NEWMAR CORPORATION

PRODUCT INFORMATION BULLETIN		
DATE ISSUED		PIB #
12/21/2015	2016 DUTCH STAR WEIGHT CARRYING CAPACITY UPGRADE	444 REVISED
YEAR / BRAND / TYPE / MODEL #		
2016 Newmar Dutch Star 40' and 43' Floorplans Only		
PRODUCT INFORMATION		
2016 Dutch Star Weight Carrying Capacity Upgrade Product Information Bulletin In response to customer feedback, Newmar Corporation is offering to upgrade the front axle on the 2016 Dutch Star 4002, 4018, 4041, 4311, 4312, 4313, 4369, 4381 floorplan coaches to provide our customers with additional front axle carrying capacity. These new front axle configurations have been developed in collaboration with our chassis supplier, Freightliner Custom Chassis Corporation (FCCC) and will be made available as upgrades to existing dealer inventory and customer coaches in the field. They will also be applied as soon as possible to future coaches with the specified floorplans produced for the remainder of the 2016 model year. A new front axle configuration with an 18,000 lb. rating will be made available for model year 2016 43' Dutch Star motor homes and is expected to provide these coaches with approximately 750 lbs. of additional front axle carryin

Figure 1 (Before Modifications)

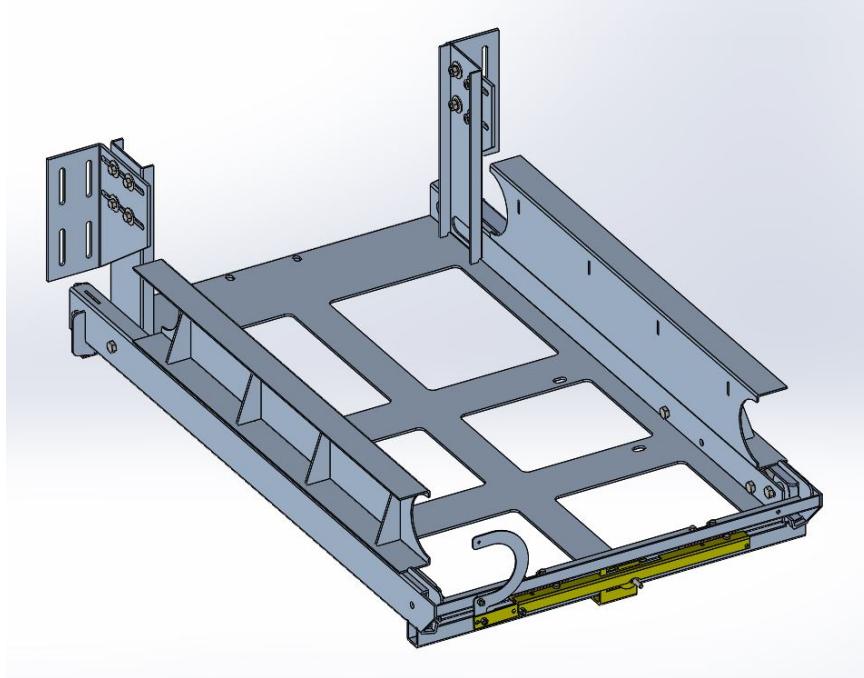
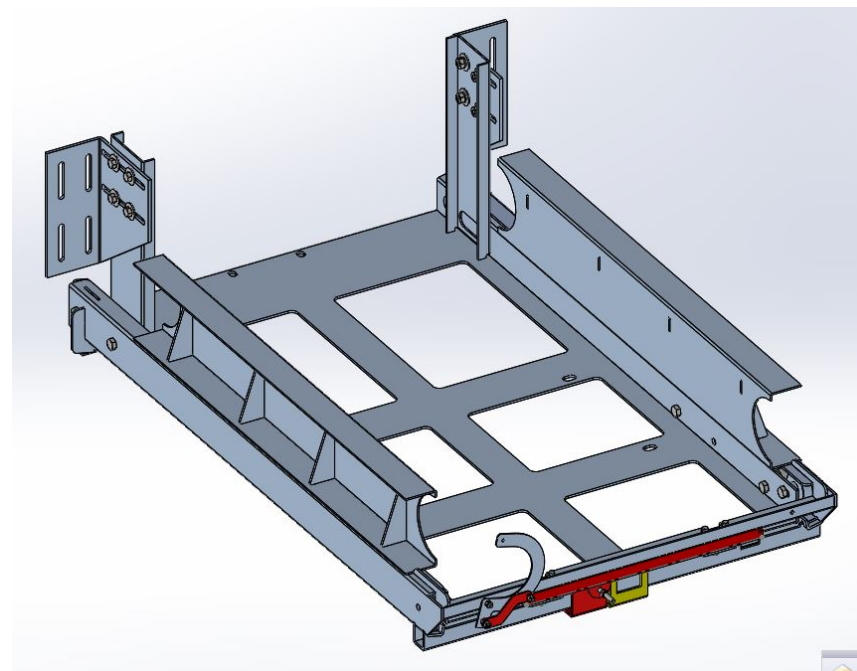
This procedure will need to be performed prior to axle upgrade

Newmar Kit Part# 134488

Figure 2 (After Modifications)

Figure 3

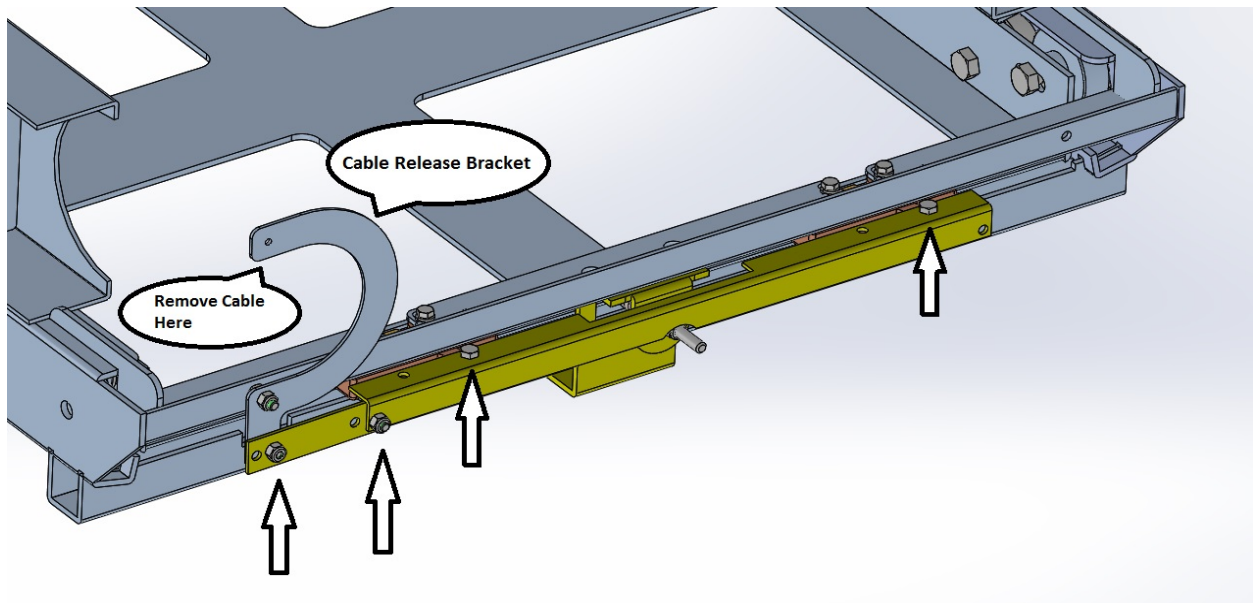
- 1.) Release the Generator Slide Tray from its catch by pulling the Slide Tray Release Handle, located behind the Front Cap Door.
- 2.) Disconnect the Release Cable from the Cable Release Bracket by loosening the cable clamp nut (not shown).
- 3.) Remove the (four) Linkage Bracket Bolts. Discard both Linkage Brackets. Place the bolts and nuts to the side for later use. See Figure 3.

Figure 4

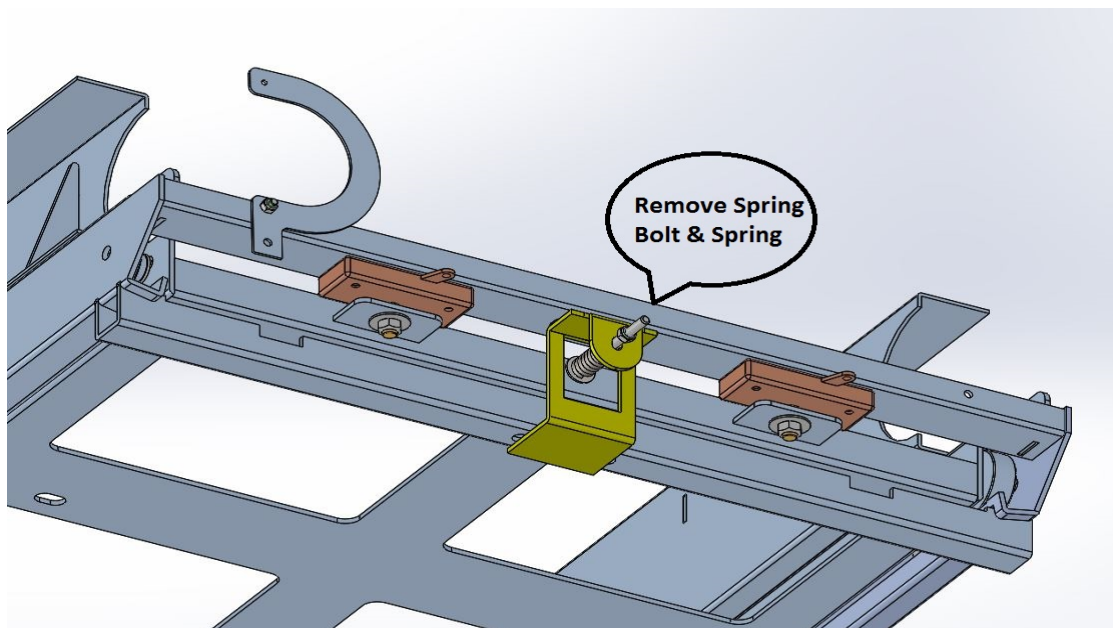
- 4.) Remove the Spring Bolt and spring from the Spring Bracket and set aside for later use. See Figure 4.

Figure 5

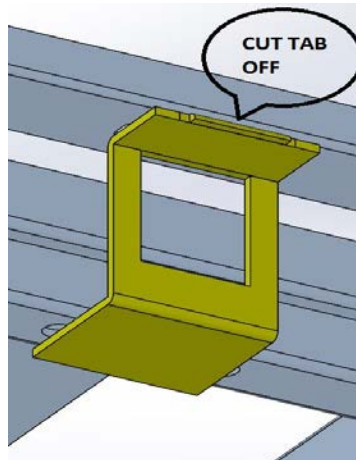
5.) Grind off the Spring Bracket Tab. See Figure 5.

Figure 6

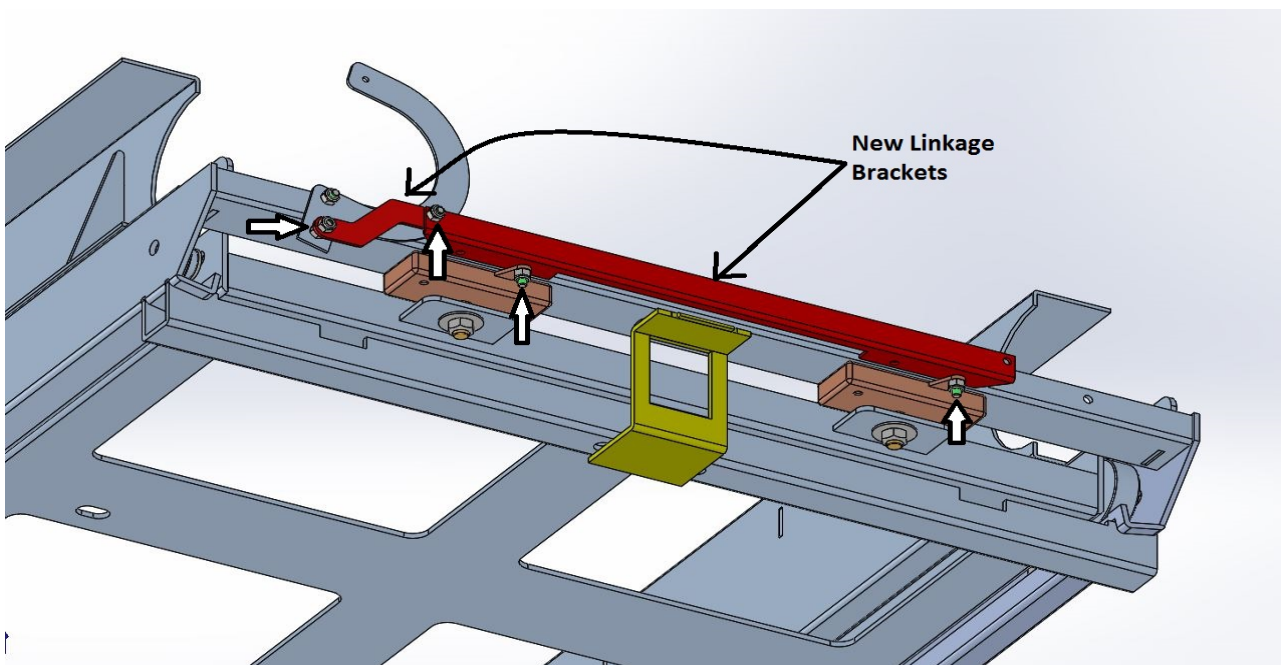
6.) Attach the (2) New Linkage Brackets using the same (4) bolts & nuts removed in step 3. Be sure the Linkage Brackets are oriented as shown in Figure 6.

7.) Attach the new Spring Bracket to the Generator Slide Tray. New Spring Bracket should be located approximately $\frac{1}{4}$ " from the Slide Tray Catch. Four $\frac{21}{64}$ " holes will need to be located and drilled into the Generator Slide Tray Frame. Attach the New Spring Bracket using the (4) $\frac{5}{16}$ -18 x 1" bolts & $\frac{5}{16}$ " Nylock nuts supplied in the Field Kit.
